DEVELOPMENT ASSESSMENT REPORT
Shire of Augusta Margaret River
2 November to 8 November 2023

DEVELOPMENT APPLICATION ASSESSMENT
Report to Manager Planning and Regulatory Services

Proposed Single Dwelling
11 (Lot 568) Tea Tree Link, Margaret River

P223545; PTY/8308

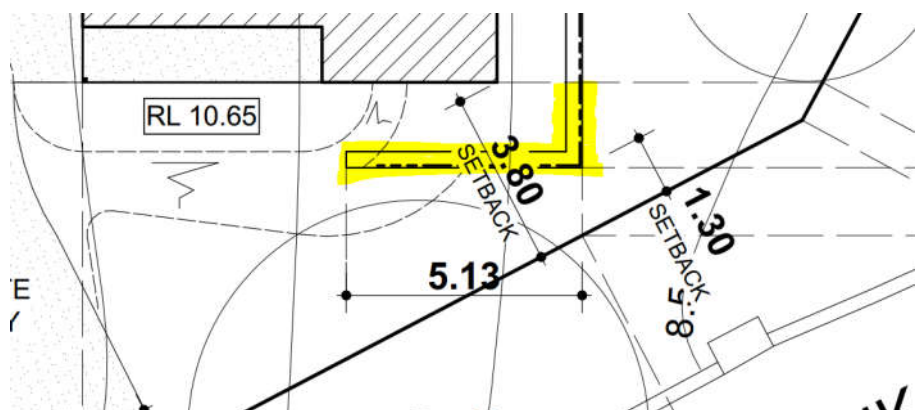
- **Variation to Part 5.3.5 Vehicular Access**

The vehicle cross over is located on the primary street, Tea Tree Link (which is on same side as the front entrance), in lieu of the secondary street.

The vehicle cross over is located on the primary street which is also on the same side as the front door/entrance. The R-Codes states that the vehicular access should be located on the secondary street or opposite street to the front door of the dwelling for a corner lot.

Although the front door and vehicle access is located off Tea Tree Link the dwelling displays major openings from habitable rooms along the secondary street which provides passive surveillance to Riverslea Drive. The proposed vehicle cross over is compliant with the other relevant deemed to comply provisions of Part 5.3.5 C5.2 and C5.3 of the R-Codes ensuring the design provides a safe vehicle access point for pedestrians and other vehicles.

The crossover is taken from the less trafficable road (Tea Tree Link) as opposed to Riverslea Drive which has significantly more traffic and access points. The cross over located on Tea Tree Link does not intercept a pedestrian foot path unlike Riverslea Drive. The design of the dwelling responds to the natural contours of the site. It would be costly to implement the vehicle access via Riverslea Drive where the slope of the lot is more significant than the chosen location, it would intercept a pedestrian foot path and be unsafe entering and existing the site when the driveway is on a significant slope.

The proposed vehicular access to the site is seen to be the most suitable location for the cross over due to the slope of the site and meets the design principles of Part 5.3.5.
